PLANNING BOARD

To: Brookline Board of Appeals
From: Brookline Planning Board
Date: March 12, 2015
Subject: Construct a garage for two tandem cars at ground level and two above on lifts
Location: 16 Monmouth Street

Atlas Sheet: 24	Case #: 2015-0009
Block: 116	Zoning: S-10
Lot: 03	Lot Area (s.f.): 16,678

PLANNING BOARD COMMENTS

SITE PLAN
 SHOWING PROPOSED GARAGE
 LOCATED AT
 16 MONMOUTH STREET
 BROOKLINE, MA

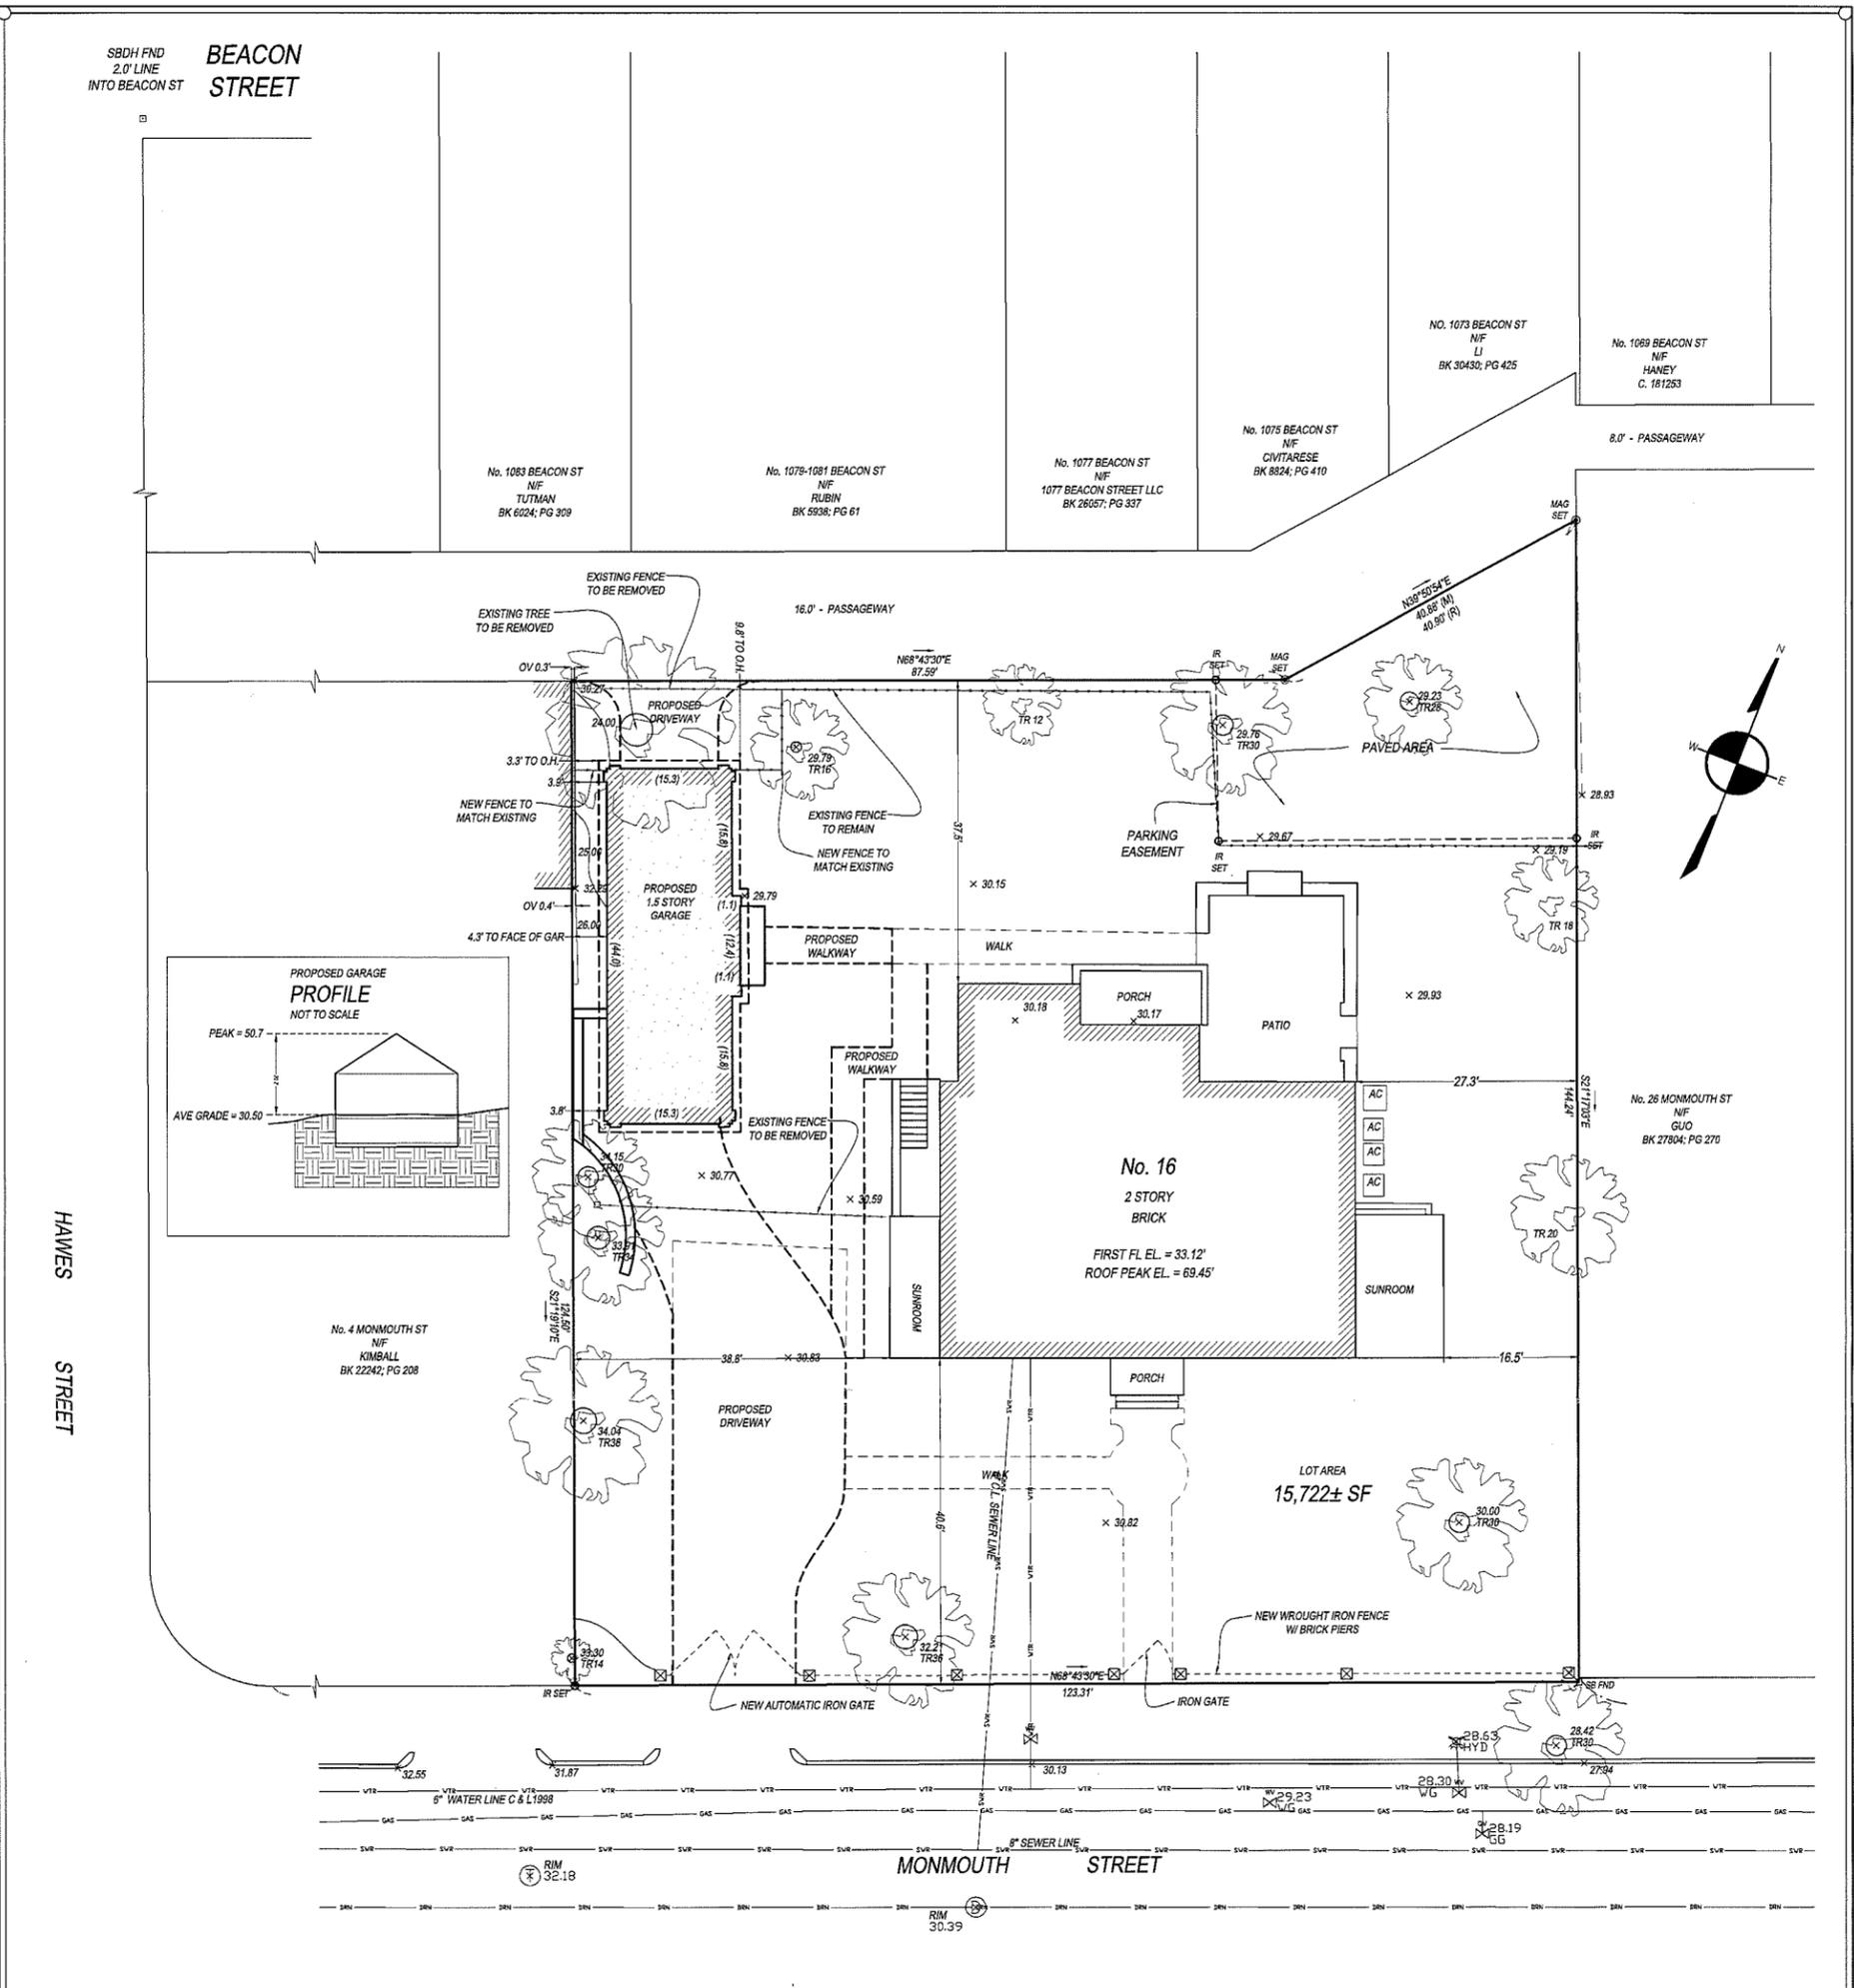
Dimensional Requirements	Required	Existing	Proposed	Relief
Front Yard Setback (garage from alley)	20 feet+	n/a	9.8 feet	Special Permit*
Side Yard Setback (garage)	10 feet+	n/a	3.3 feet	Special Permit*

+Because the garage is over 15’ in height and is not at least 75’ from the street line, it does not qualify for the reduced side yard setback requirement for accessory buildings under **Section 5.63**, which would allow a garage under 15’ tall to be located 6’ from a side lot line. An alley is considered a “street” under the Zoning By-law.

The Planning Board is supportive of this proposal to construct a new garage to serve the single-family at 16 Monmouth Street. Although the garage needs setback relief, its location and design is sensitive to the side abutter, and a four car garage is allowed for a single family dwelling on a lot greater than 10,000 s.f. (See Use # 54). By using stacker technology, the garage’s footprint is relatively small in size, particularly considering the number of vehicles it serves, and it has been attractively designed and relates well to the architecture of the existing structure.

A parking easement in the northeast corner of the lot, adjacent to the rear alleyway, had been granted previously to residents of an adjacent lot. Because this easement area is fenced off from the single family lot and accessed from the alleyway, it does not appear to be part of the single family property. Parking by off-site residents is allowed by special permit.

Therefore, the Planning Board recommends approval of the proposed site plan by Boston Survey, dated 11/5/14, and plans by Colin Smith Architecture, dated 11/11/14 and last revised 11/20/2014, subject to the following conditions:

1. Prior to the issuance of a building permit, the applicant shall submit a final site plan, indicating all landscaping and fencing, subject to the review and approval of the Assistant Director of Regulatory Planning.
